SUBMISSIONS REPORT

SSD-36138263 | Augusta
Street Warehouse and
Distribution Centre

Prepared for
**THE TRUSTEE FOR HUNTINGWOOD PROPERTY
TRUST**
26 March 2024

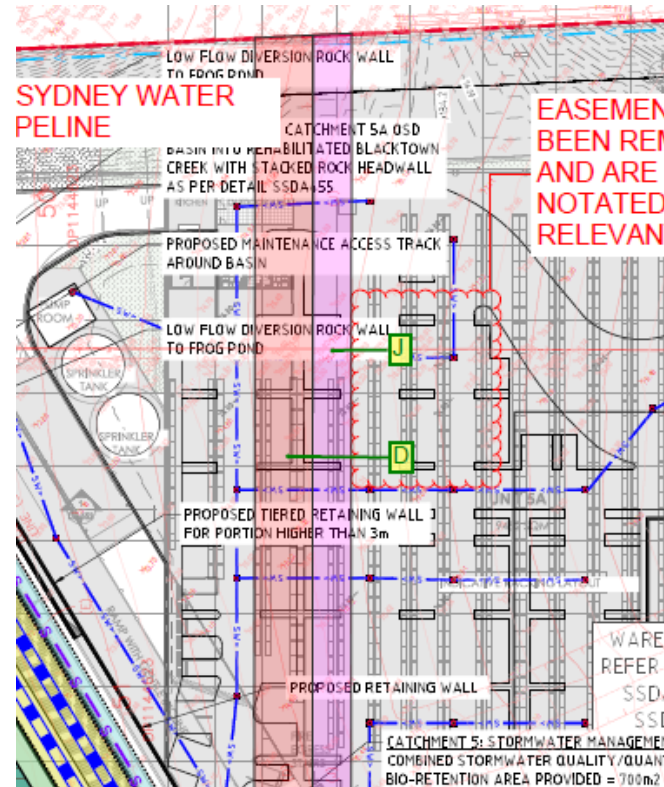
The architecture plans show warehouse 5A is proposed to be built over the water supply easement. Sydney Water deems this unacceptable and suggests the proponent either relocate the building outside of the easement or relinquish the easement subject to approval from Sydney Waters.

The subject water supply easements are (D) and (J) in the red and purples notations on the figure below (also refer to Sheet 5, Appendix B within the Sydney Water Letter). These easements have been extinguished as they are no longer listed on the five relevant titles. As such, they do not apply to the site. Warehouse 5A is not proposed to be built within any registered easements.
